Subject: Cable Tray Support Review Questions  
Comanche Peak Steam Electric Station  
Independent Assessment Program - Phase 4  
Job No. 84056

## ATTACHMENT A

### CABLE TRAY SUPPORT REVIEW QUESTIONS

FIGURE 2A - TYPICAL TRAY CLAMP  
(NOT TO SCALE)

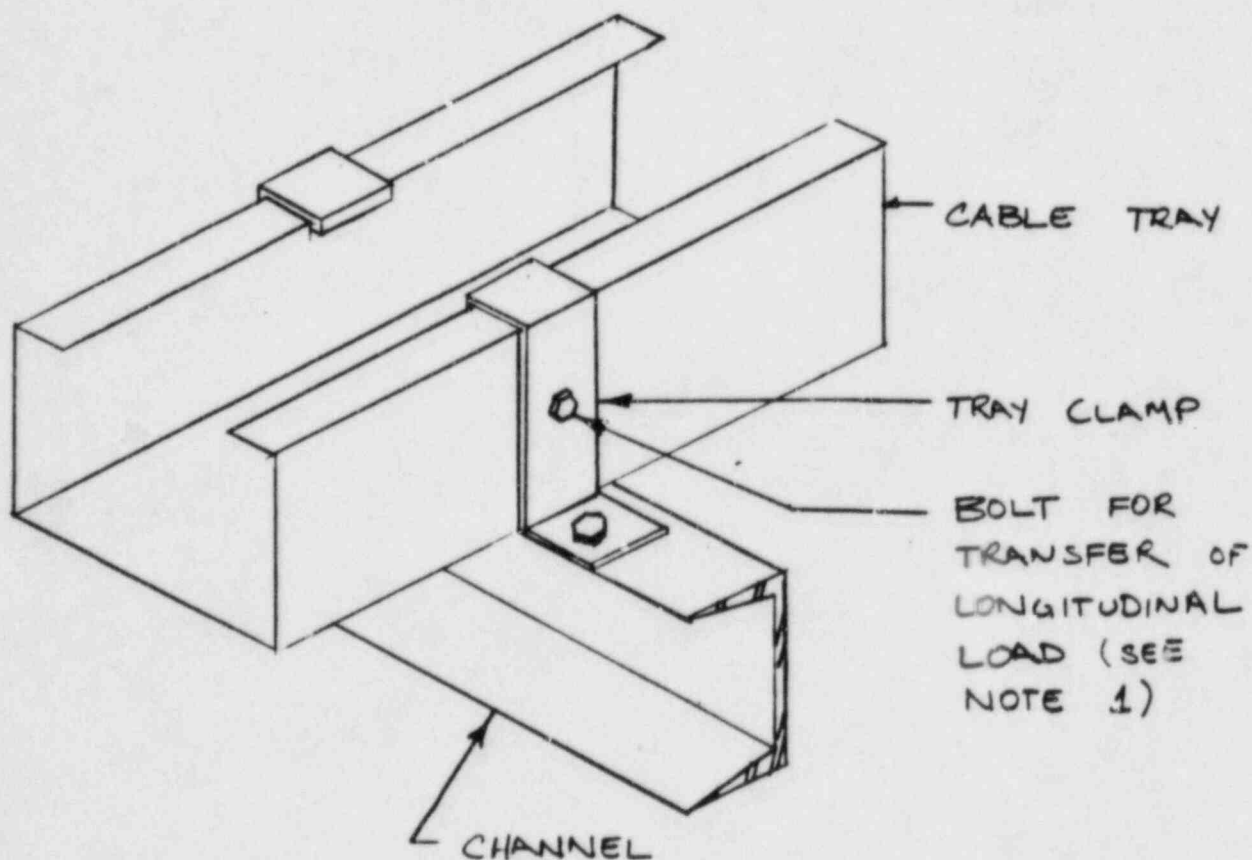
2.1 Cable trays are attached to supports by friction type or heavy-duty tray clamps. The former type resists transverse and vertical loads while the later resists transverse, vertical and longitudinal loads. The connection details for these clamps require that they be bolted or welded to the top of the cable tray support beam. A typical connection is shown in Figure 2A. Such connections provide a load transfer which is eccentric to the major axis and to the shear center of the channel sections typically used in the cable tray support designs. As a result, several effects are not considered in the design of the supports.

FIGURE 2B - ECCENTRICITY OF TRANSVERSE  
LOAD  $P_h$  FROM MAJOR AND  
MINOR AXIS OF A CHANNEL  
(NOT TO SCALE)

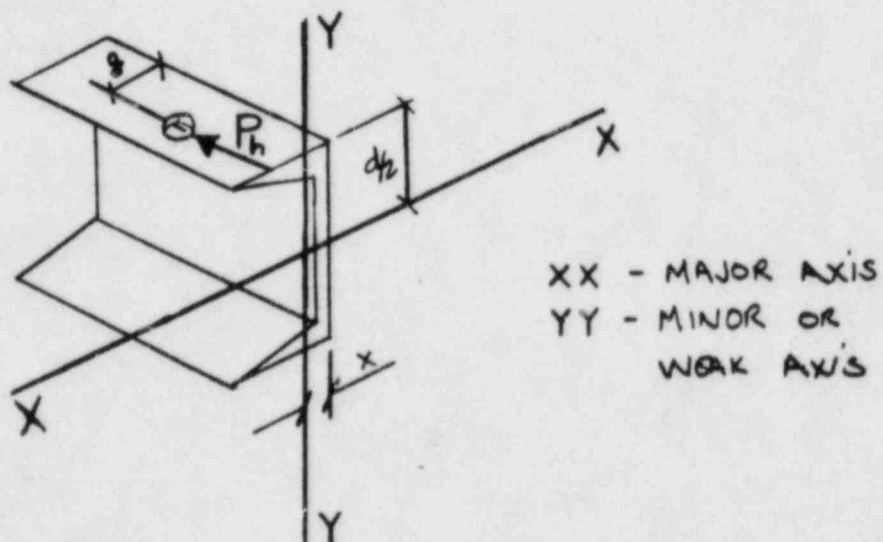
##### 2.1.1 Major and Minor Axes Flexure

As noted in Figure 2B, the location of the transverse load,  $P_h$ , is eccentric to the major axis by a distance  $d/2$ , where  $d$  is the channel depth. The effect of this eccentricity is an increase in major axis bending. Minor axis bending will occur because  $P_h$  is eccentric to the minor axis by a distance of  $(g-x)$  where  $g$  is the gage distance and  $x$  is the location of the neutral axis relative to the back of the channel web.

Please provide Cygna with documentation showing the cable tray supports are capable of resisting the applied loads when the effects of the eccentricities described above are considered.

FIGURE 2C - ECCENTRICITIES OF VERTICAL AND LONGITUDINAL LOADS  
(NOT TO SCALE)

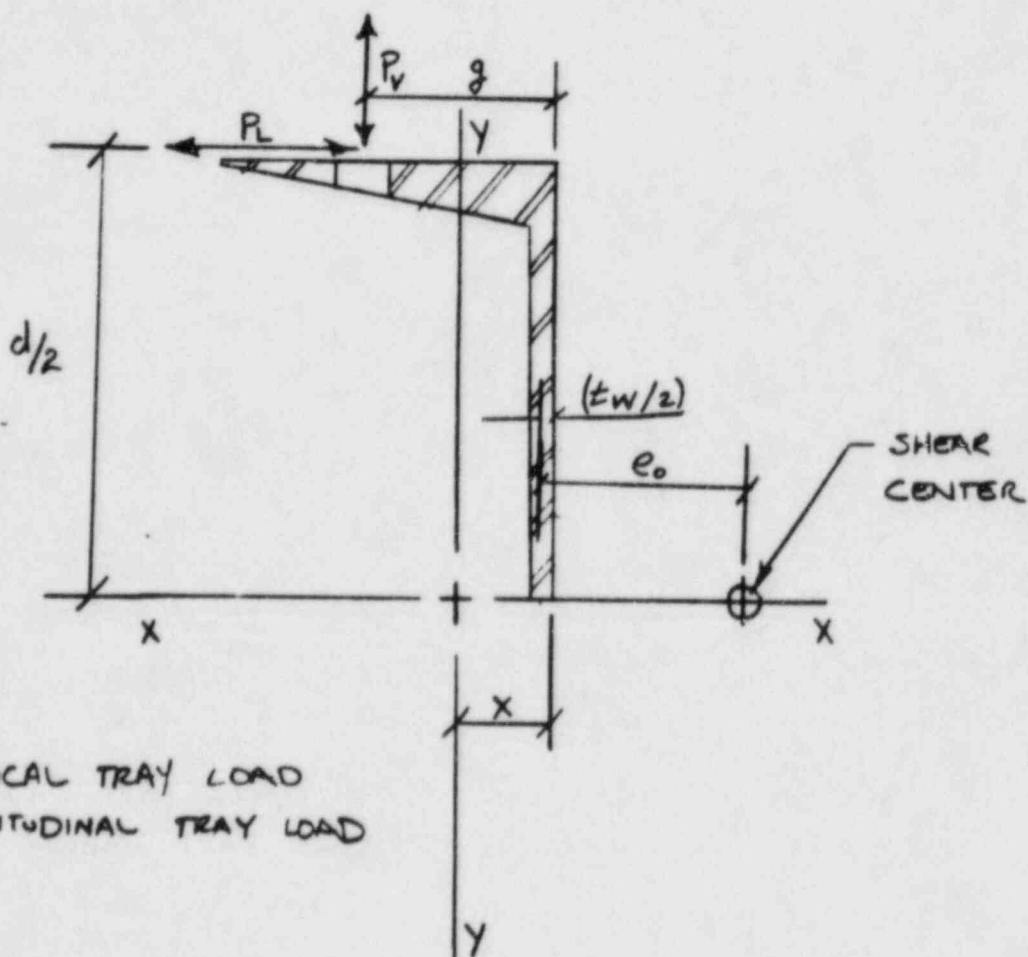
##### 2.1.2 Torsion due to Vertical Loads

As shown in Figure 2C, vertical cable tray loads are applied eccentrically to the shear center of the channel section which induces torsional moments into the beam. Cygna has

noted that only beam members for Regular Case cable tray supports Details A<sub>i</sub>, B<sub>i</sub> and C<sub>i</sub> and Detail SP-7 with brace have been analyzed for the effects of eccentrically applied vertical loads. Cygna is currently reviewing these calculations. No other cable tray supports have been analyzed for the effects of torsion due to vertical loads.

#### 2.1.3 Torsion Due to Longitudinal Loads

As shown in Figure 2C, longitudinal cable tray loads are applied eccentrically to the major axis (X-X) of the channel section which induces torsional moments into the beam member. Cygna has noted that only Detail SP-7 with brace has been analyzed for the effects of eccentrically applied loads.

FIGURE 2D - ECCENTRIC MEMBER CONNECTION

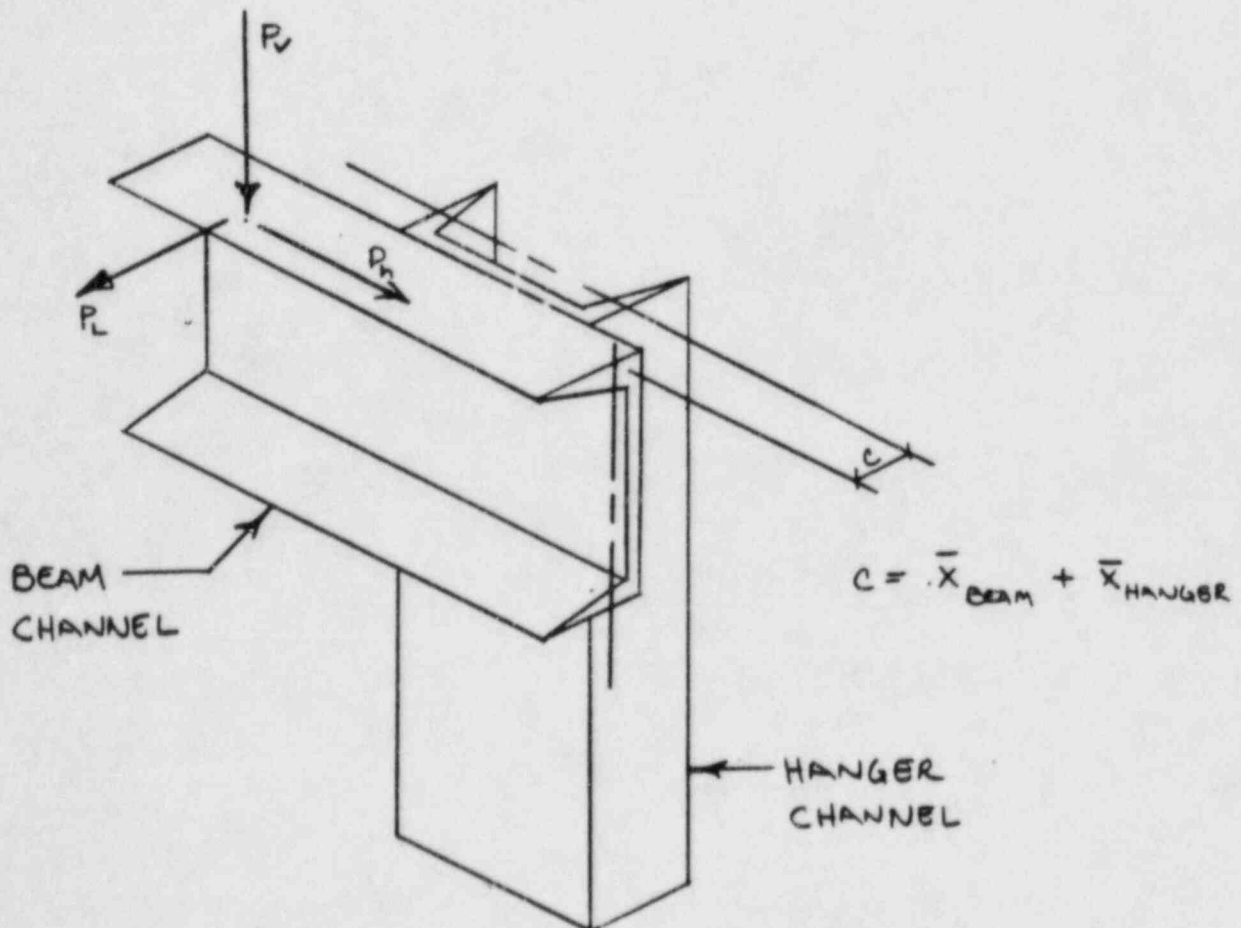
#### 2.2 Eccentric Connections

The cable tray supports are primarily constructed of channel sections for the hanger and beam members and angles for bracing members. (For Cygna's concerns regarding angles, reference Cygna's letter 84056.027, question 2.) Figure 2D shows the eccentricity between the neutral axis of a typical beam and hanger connection. Cygna has noted that the effect of this joint eccentricity has not been considered in the design calculations.
